Working Party on Customs Questions affecting Transport

**Informal Ad hoc Expert Group on Conceptual and
Technical Aspects of Computerization of the TIR Procedure**

Approved amendments to the eTIR conceptual, functional and technical documentation - v.4.2a

Note by the secretariat

Figure 3
Guarantee state chart diagram

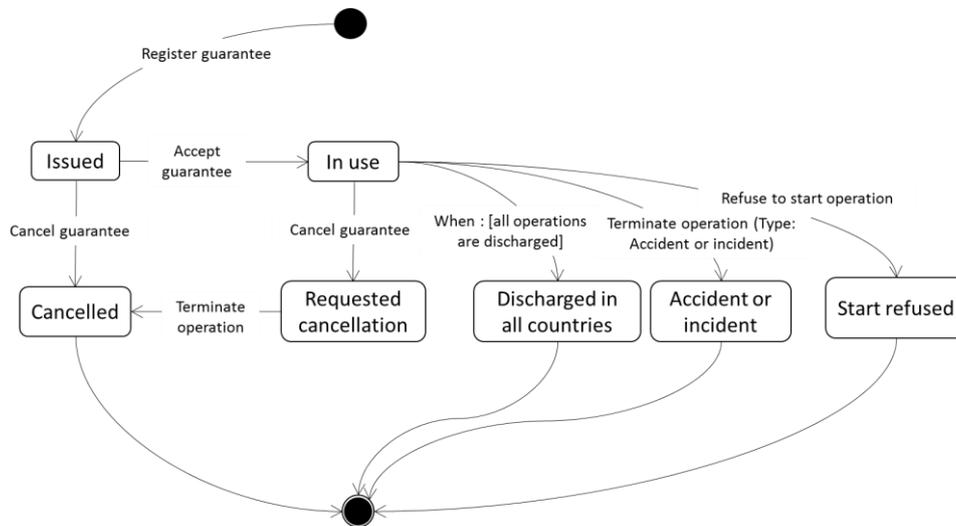
6. Chapter “3.1.2 Guarantee state chart diagram” of the eTIR concepts document will list the two additional guarantee statuses.

7. Figure 3 in the same document will be amended as follows:

CL22	Guarantee status (eTIR)
001	Issued
002	In use
003	Cancelled
004	Requested cancellation
005	Discharged in all countries
006	Accident or incident
007	Start refused

a. Message sequence for countries of departure

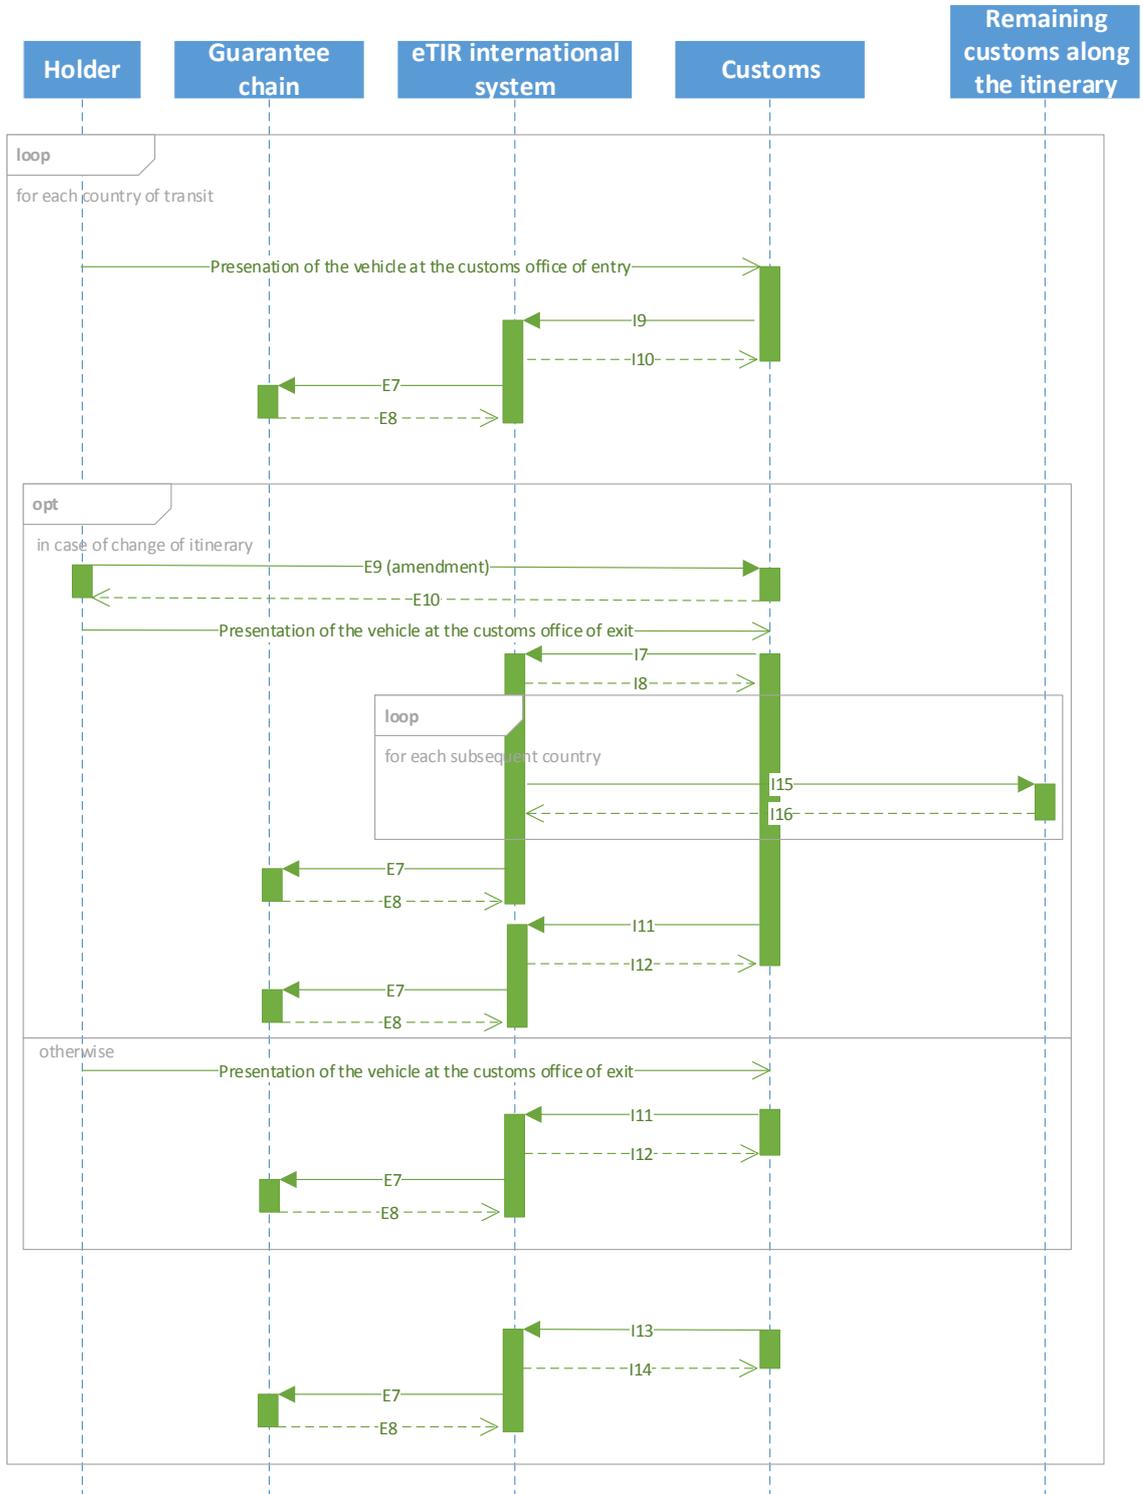
3. The sequence diagrams describing the standard sequences of eTIR messages for a country of departure, transit and destination (as contained in Annex) will be included in the next revision of the eTIR functional specifications as a new Annex.
